Service Bulletin

Subject: AIR BAG SYSTEM WARNING LIGHT ON WITH DTC B1933 OR B2233	Bulletin No: 08-003/12
	Last Issued: 08/24/2012

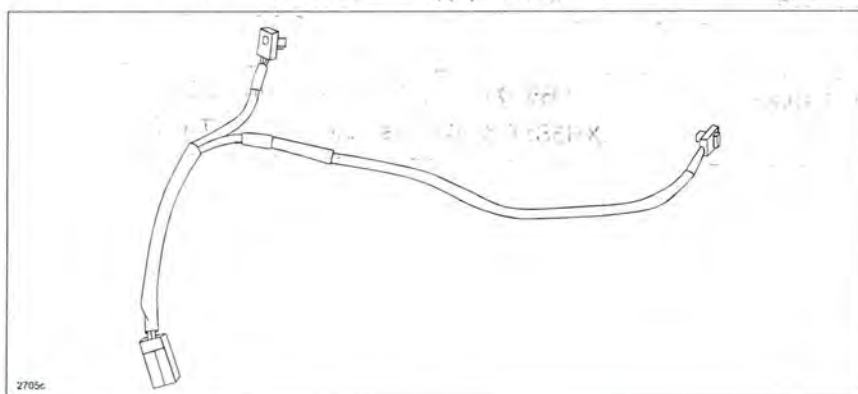
This is caused by poor contact at the terminals of the short harness that exists between the passenger-side air bag module and the SAS control module. To correct the problem, the terminals installation procedure has been changed.

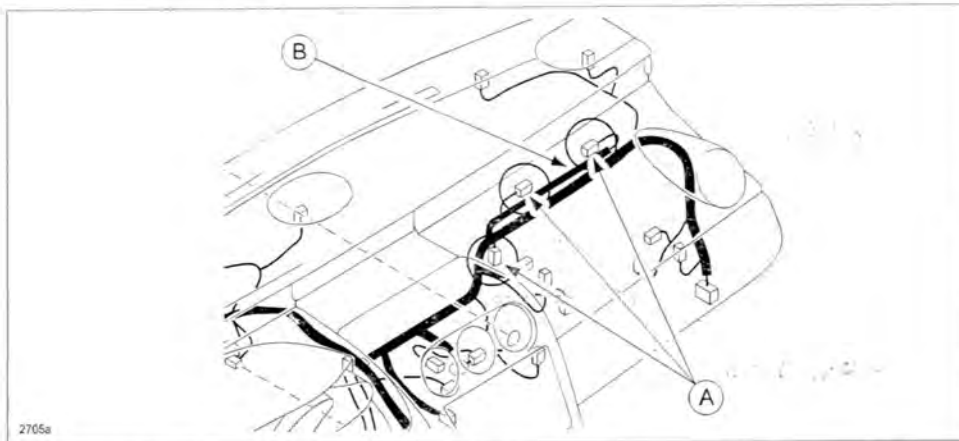
- a. Disconnect the connectors (A) and remove the original short harness (B).

- b. Cut the connectors off the original harness so that it cannot be used again.
c. Route the new short harness (A) over the vehicle harness as shown.

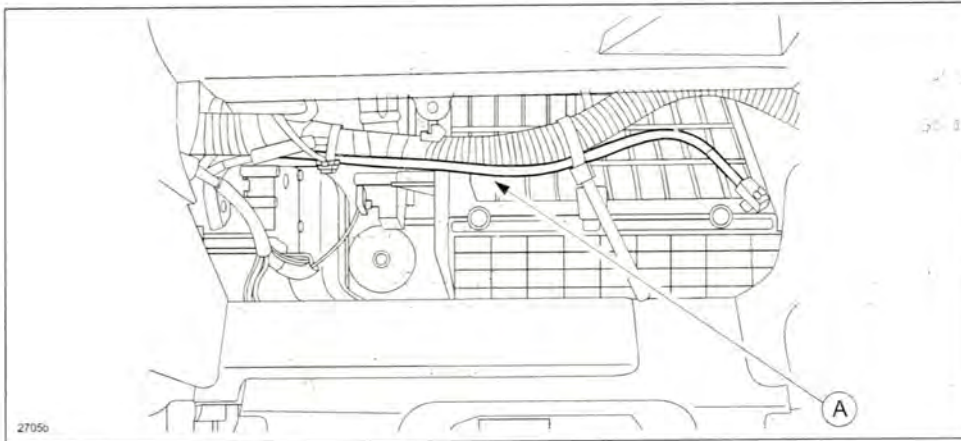
CAUTION: Keeping a safe distance from the bracket, route the new short harness.

- d. Connect the connectors of the new short harness.
e. Secure the new short harness to the vehicle harness using tie wraps, then secure the 0810-117 connector with tape.
5. Connect the negative battery cable.
6. Using M-MDS, check the resistance value between the passenger-side air bag module and the SAS control module as follows:
- Connect the M-MDS to the DLC-2.
 - After the vehicle is identified, select the following items from the initialization screen of the M-MDS..
 - Select "DataLogger."
 - Select "Modules."
 - Select "RCM."
 - For B1933, select "RES_AB_P" and for B2233, select "RES_AB2_P."
